20 RESPONSE TO COMMENTS

The Draft Environmental Impact Report (DEIR) for the Coyote Creek Agrivoltaic Ranch Project (the project) was circulated on March 5, 2025 (State Clearinghouse Number 2022010271) for a public review period that ended on May 5, 2025. A total of 74 individual letters were received during the comment period and one additional letter was received after the close of the public review period. This Final EIR (FEIR) provides responses to comments received on the DEIR. Each letter has been assigned a number, as indicated below.

This comment restates the same concerns previously raised by LSCE in other comments. Refer to Master Response E.

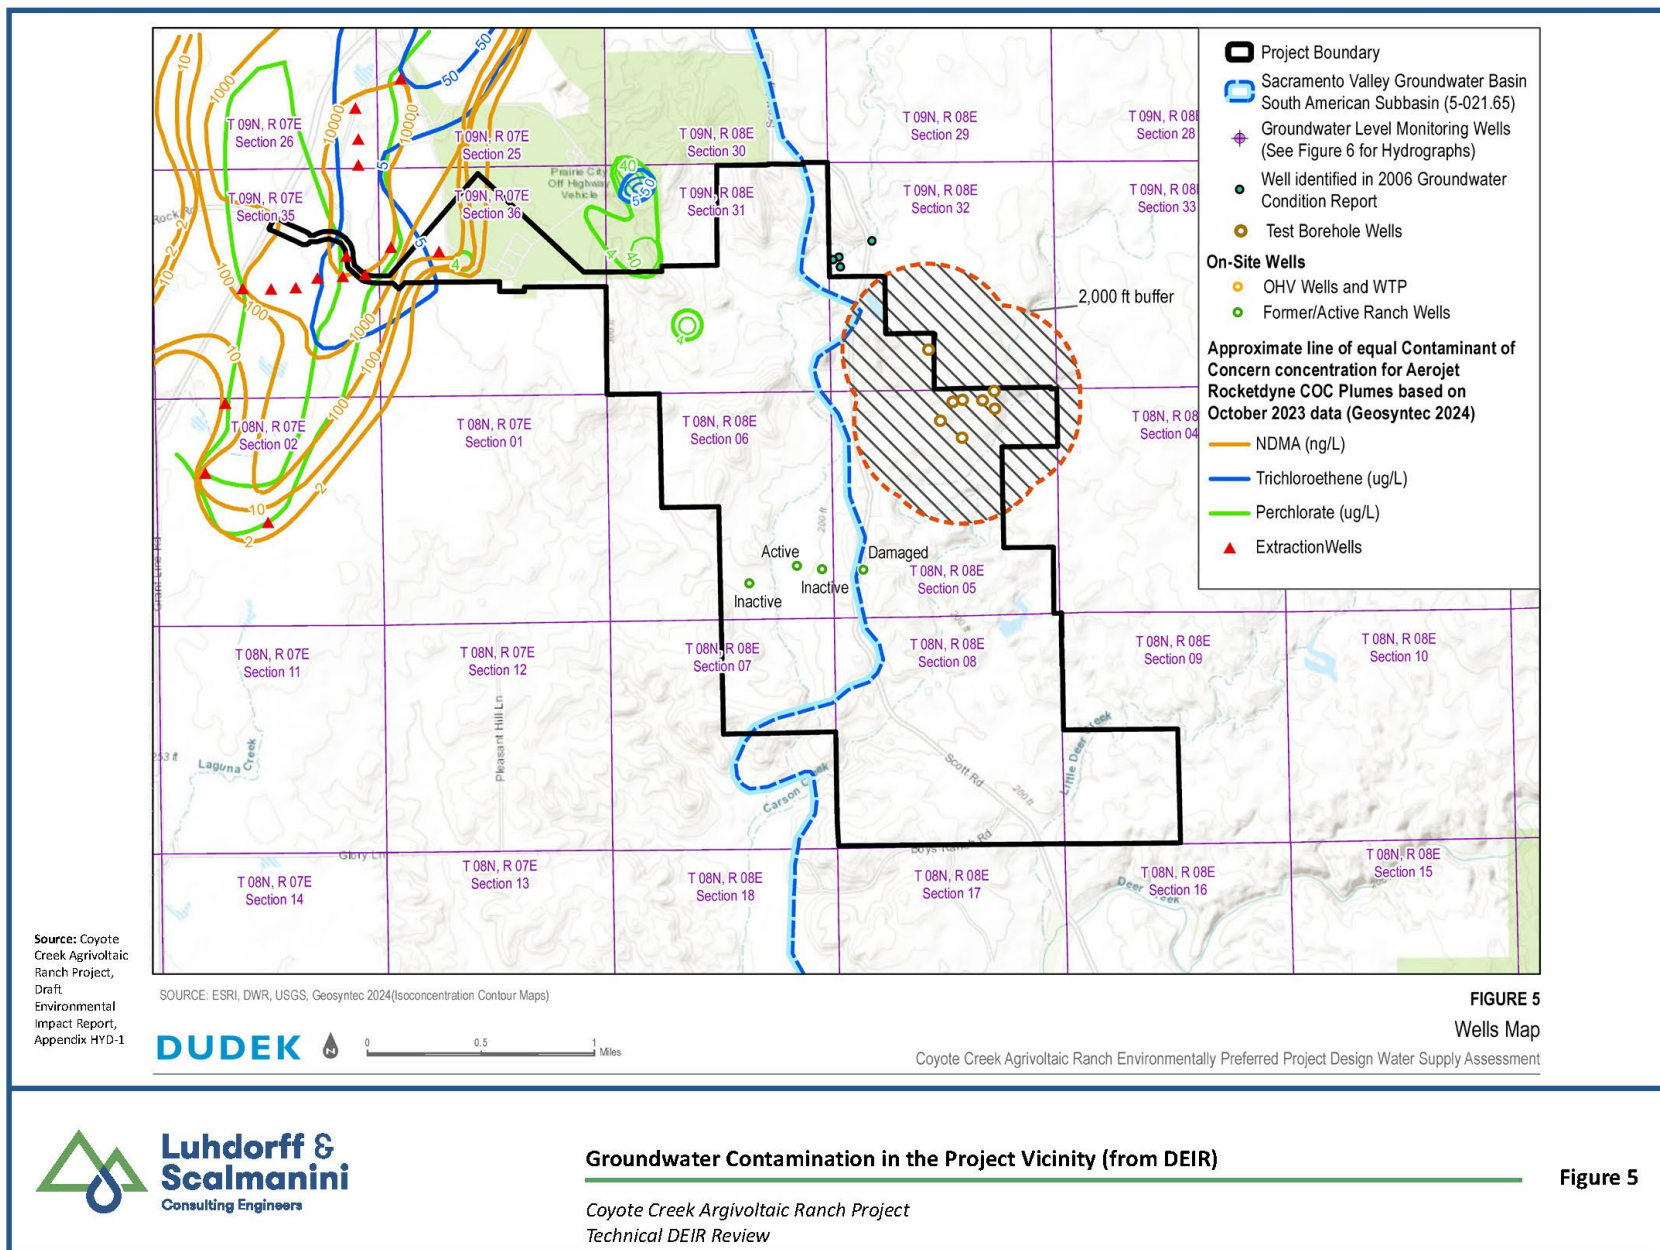
COMMENT 03-286

This comment consists of Figures 1 through 5 attached to the LSCE comment letter. These figures were reviewed and considered by the County in the responses to comments provided above.
